**CITY OF FREDERICKSBURG  
HISTORIC REVIEW BOARD**

**TUESDAY, FEBRUARY 14, 2023**

**6. CERTIFICATE OF APPROPRIATENESS APPLICATIONS  
CONSENT AGENDA**

**Historic Review Board**  
**Application Information**

# SOUTH ELEVATION

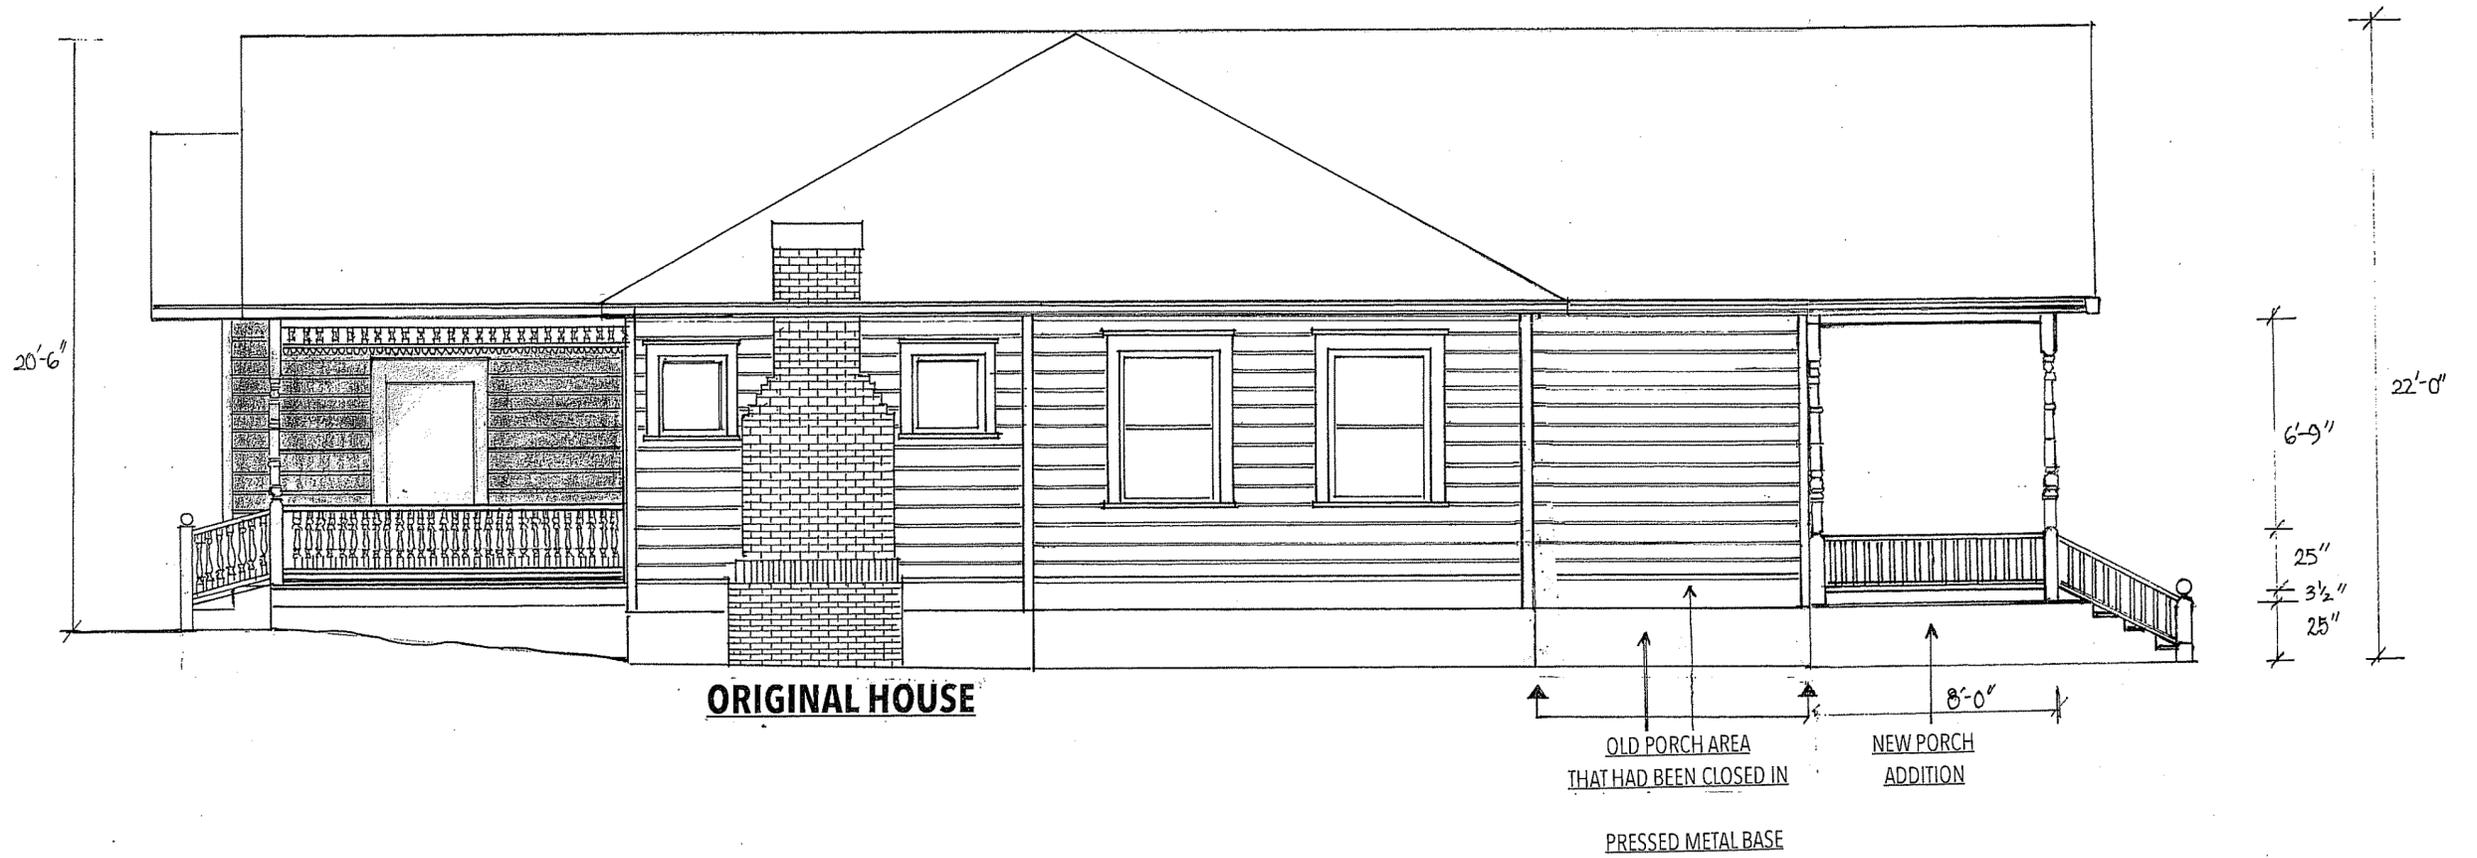
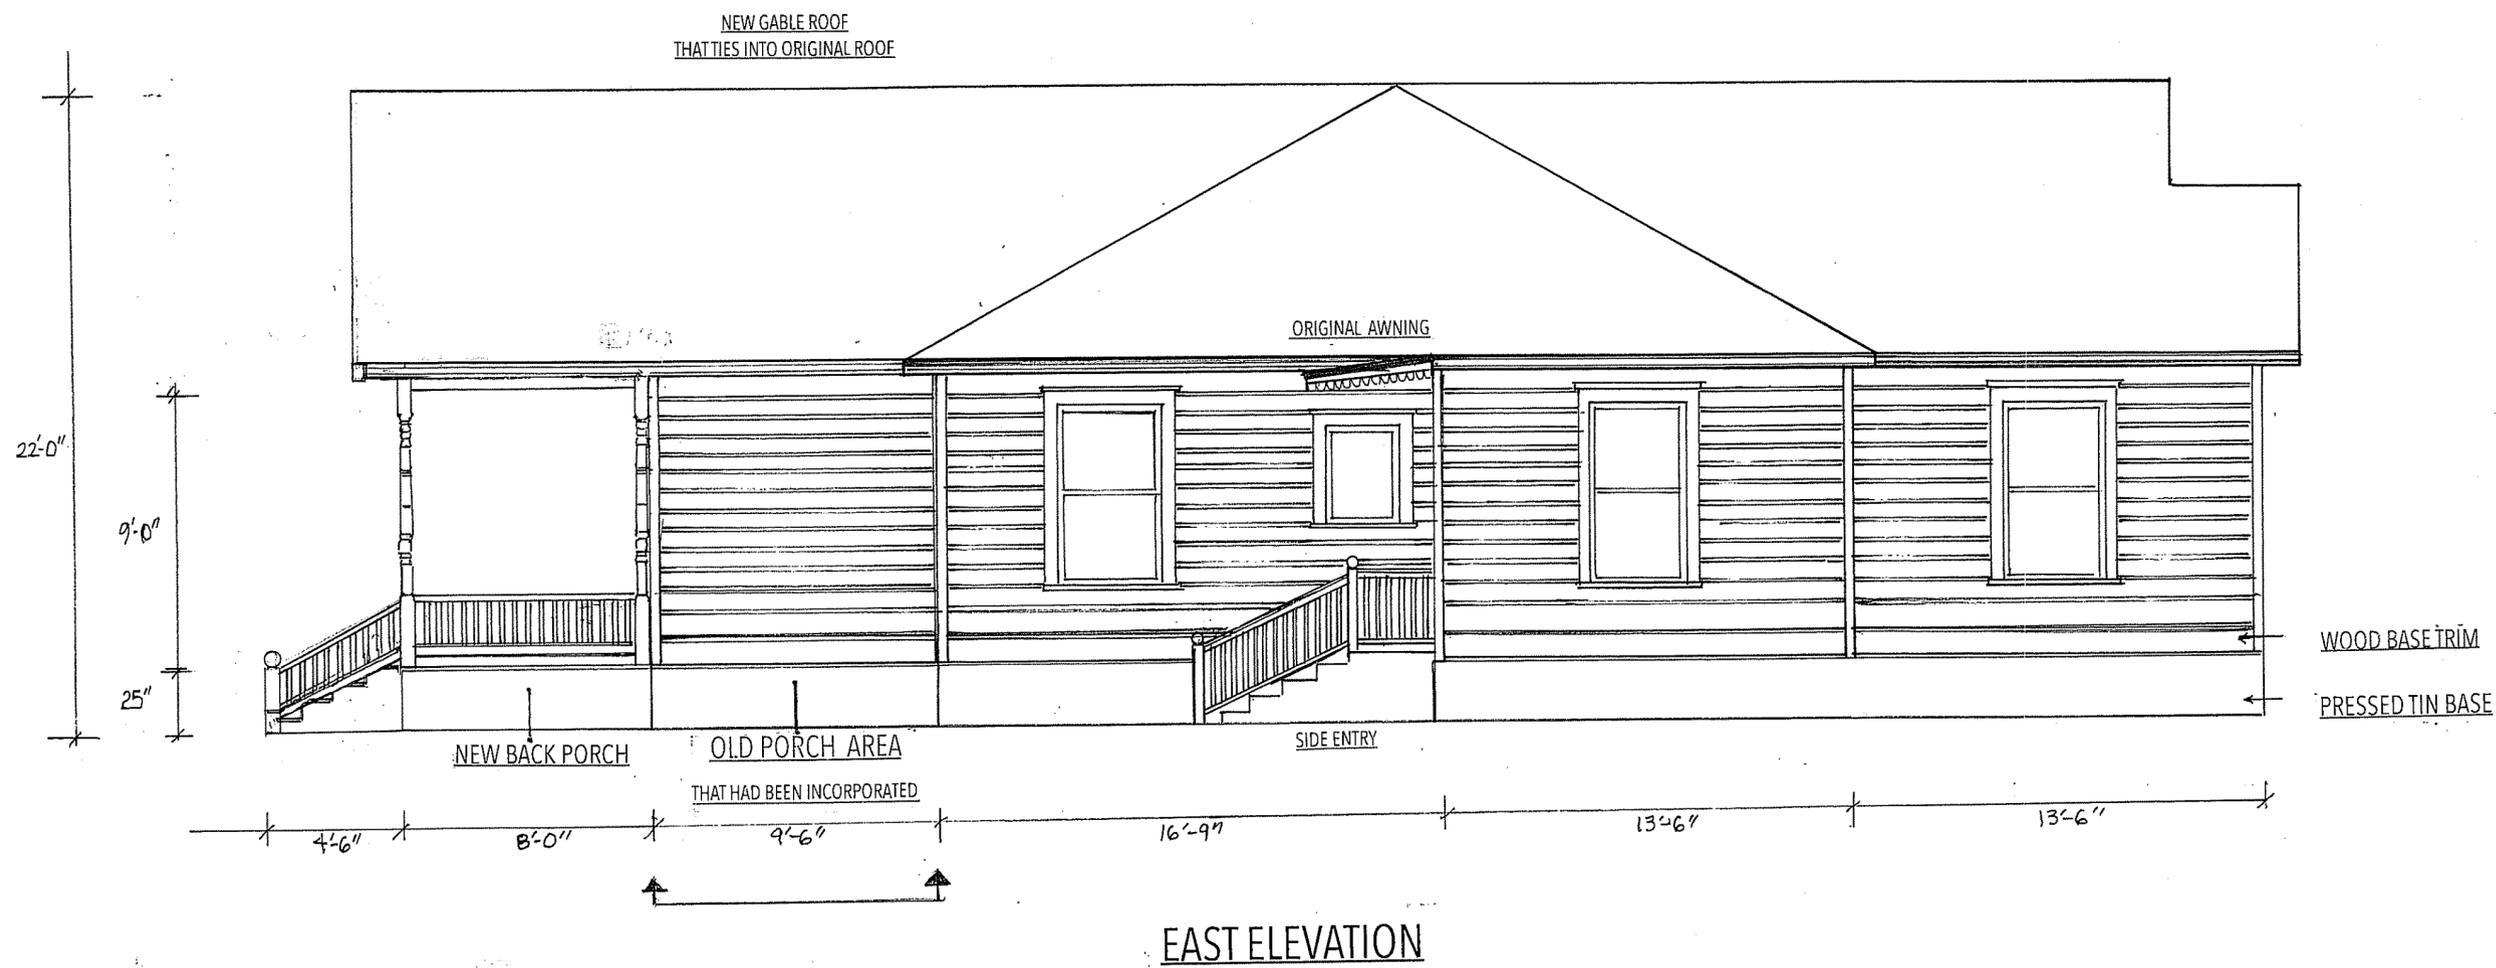
The proposed rear addition is an open porch that will not be readily visible from the street. The original porch was previously enclosed. The design will still allow the original enclosed porch to read as such. Staff recommends approval as submitted.

**PROPOSED FRONT ELEVATION**  
SCALE: 1/4" = 1'-0"

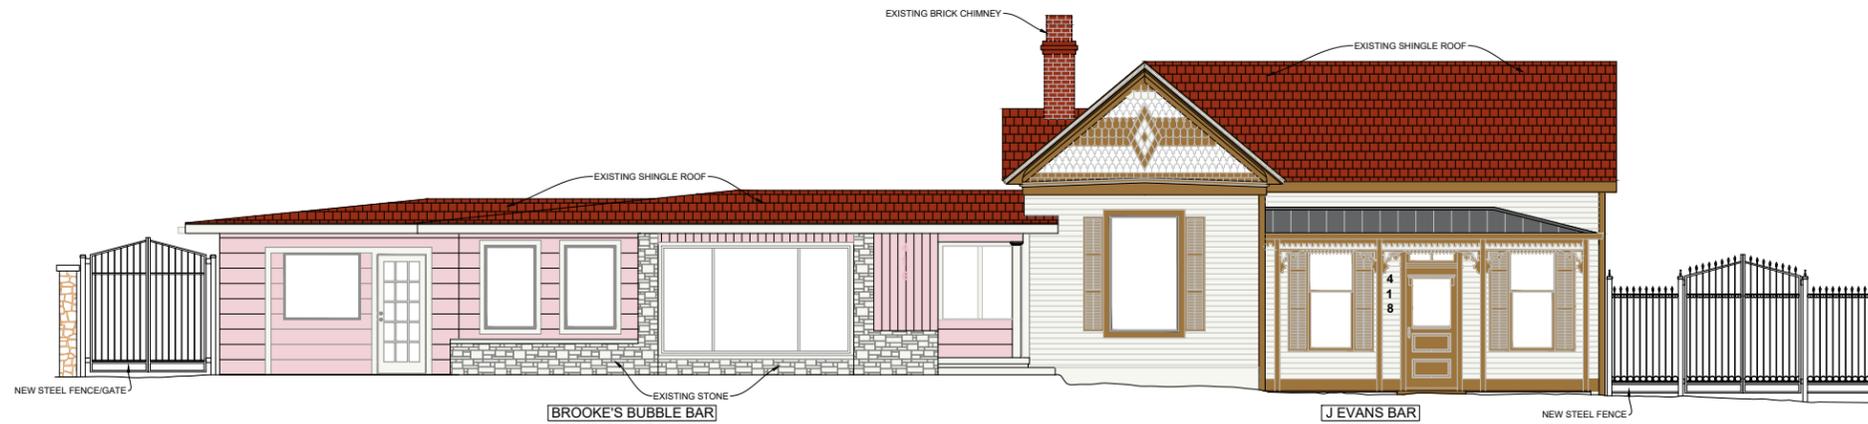
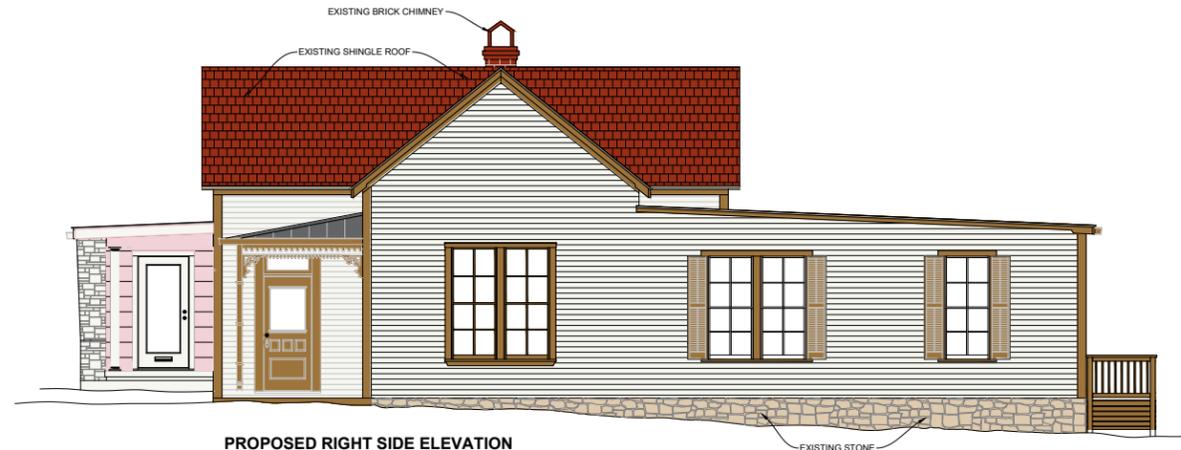
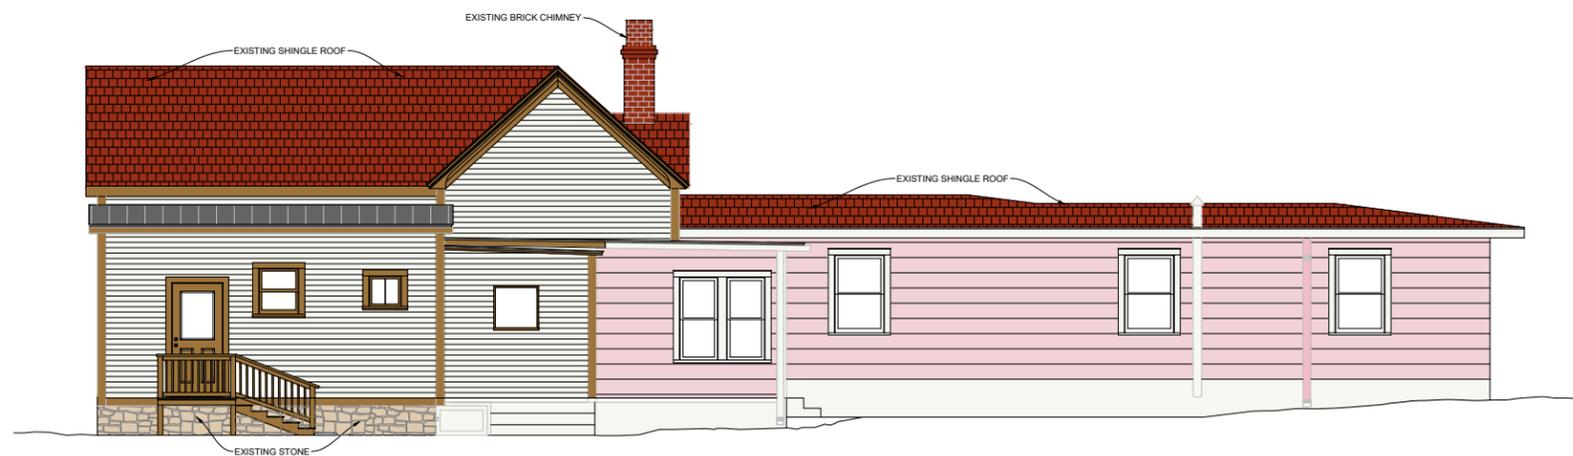
The case was first presented to the Historic Review Board on January 10, 2023. The applicant was advised to continue to work on the color scheme and change the design of the fence on the west side to better match the mid-century style of that side of the property. The structure in question is a unique structure with two very distinct time periods represented. The original structure is a one-story L-plan house of Victorian style (418 E Main). The addition on the west side of the original house is a good representation of midcentury features including flat roofed porch under the main roof form (416 E Main). Two businesses intend to occupy the structure, one in each distinct portion.

- A. The applicant has researched mid century paint colors and has documented examples of pinks used in the 1960s. They proposed Sherwin Williams #6582 Impatiens Petal as the primary color and High Reflective White as the trim color. This is the inverse of the original submittal.
- B. The colors used for the Victorian have been switched so the Sconce Gold is the trim color and High Reflective White is the base color, removing the previously presented black trim color.
- C. The proposed fencing was discussed at the previous meeting. The only alteration of the new design is that the west side fence be changed to better match the mid-century style of the house.

HRB SITE PLAN

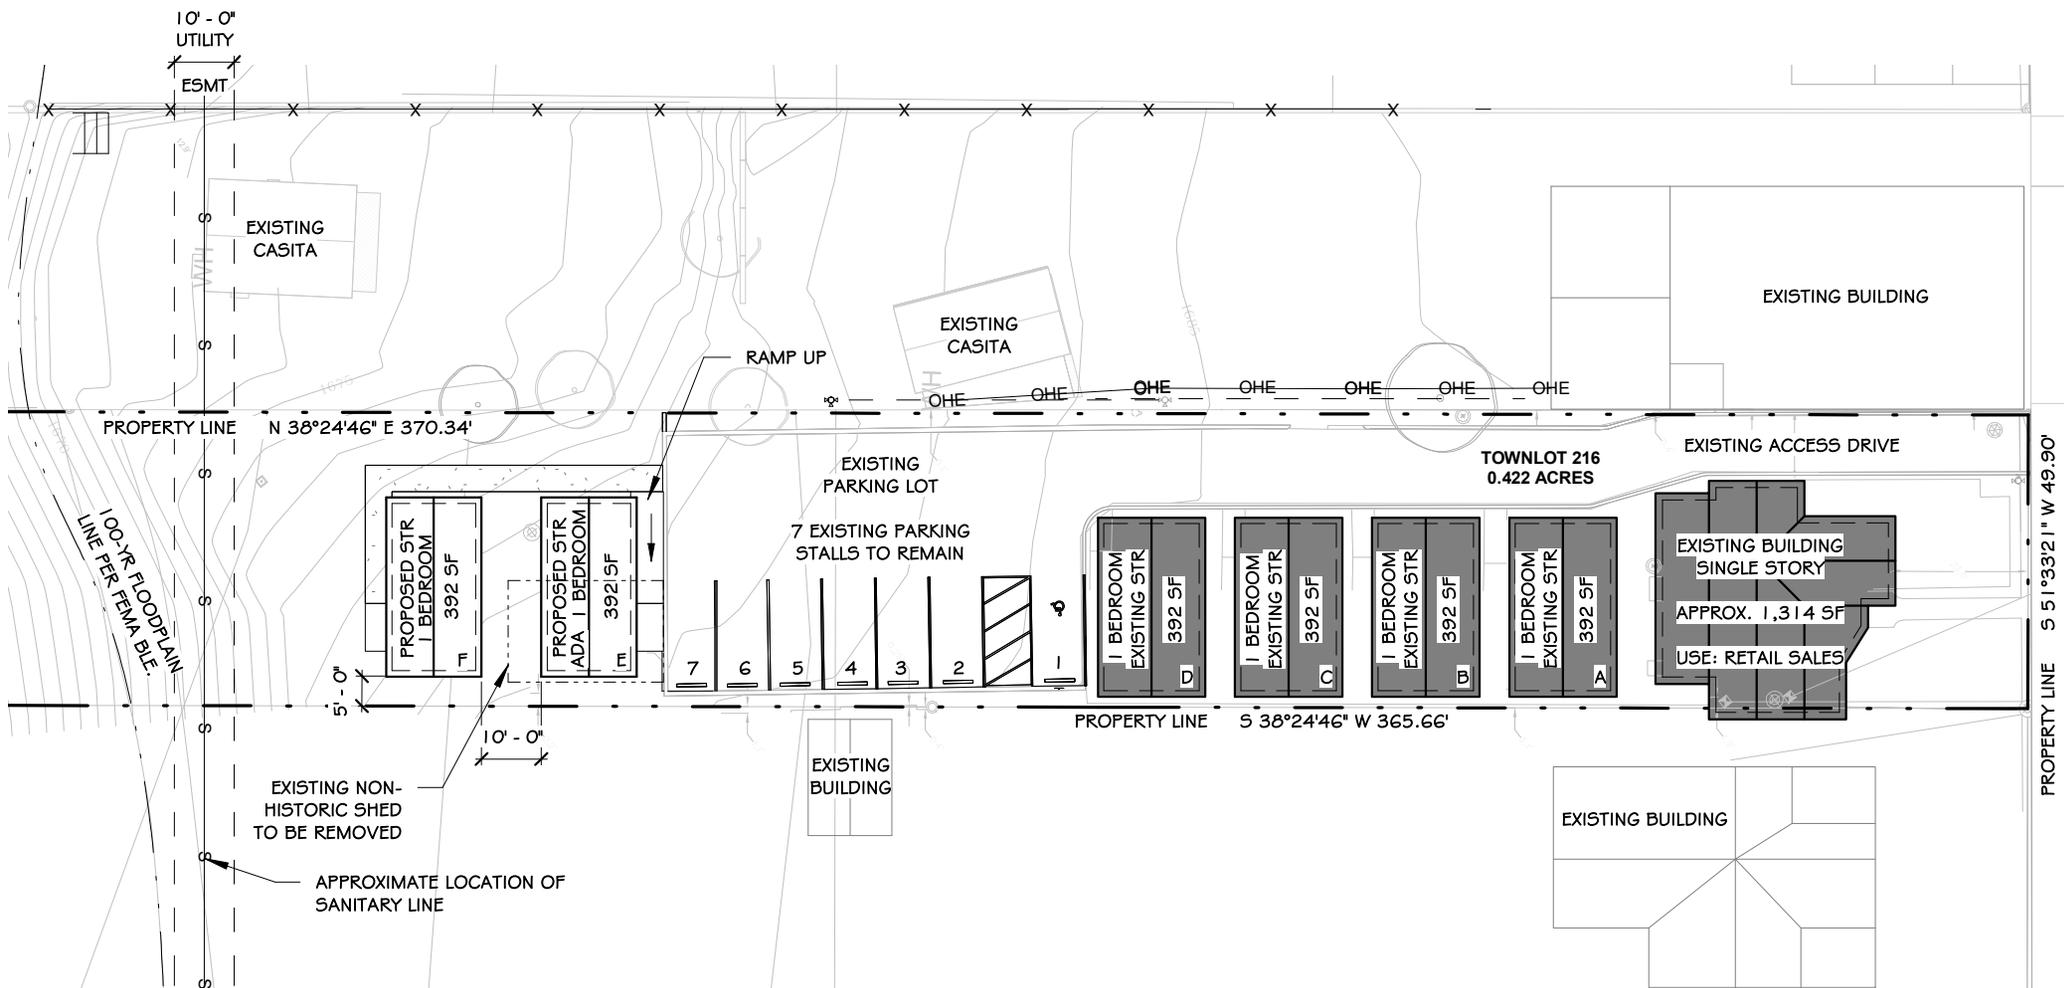
- A. The property has a high rating. The shed in question is not of historic age or integrity. Staff recommend approval of the demolition.
- B. The proposed new construction is to be located behind the existing casitas and parking lot. The casitas will match the already constructed casitas at 411 E. Main. The new will be pushed back further on the lot and should be less visible than the existing. Staff recommends no more than 3 colors be used for the new casitas.

HRB SITE PLAN

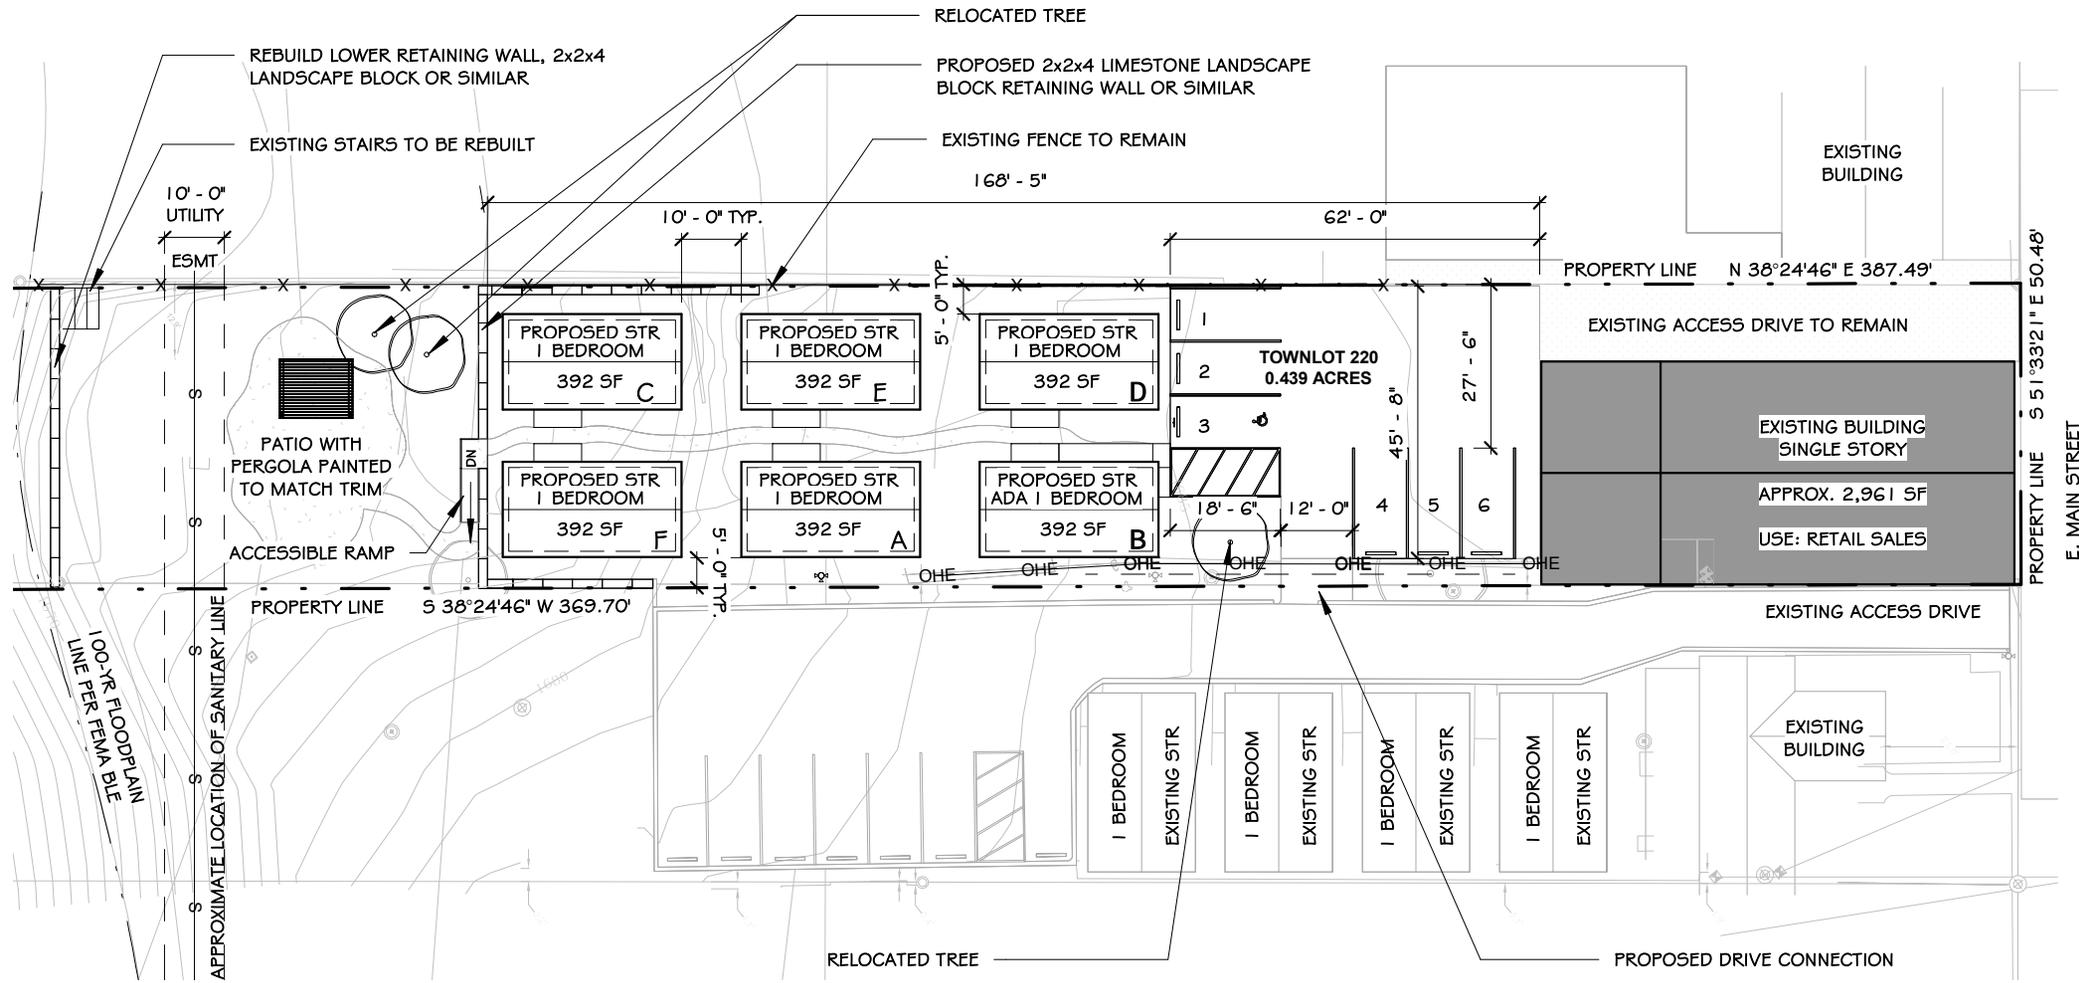
- A. The property has a low rating. The structures in question are not of historic age or integrity. Staff recommend approval of the demolition.
- B. The proposed new construction is to be located behind the existing commercial store front. The casitas will match the already constructed casitas at 411 E. Main. The new will be pushed back further on the lot and should be less visible than those at 411. Staff recommends no more than 3 colors be used for the new construction.
- C. The pavilion will not be readily visible given its location on the lot.
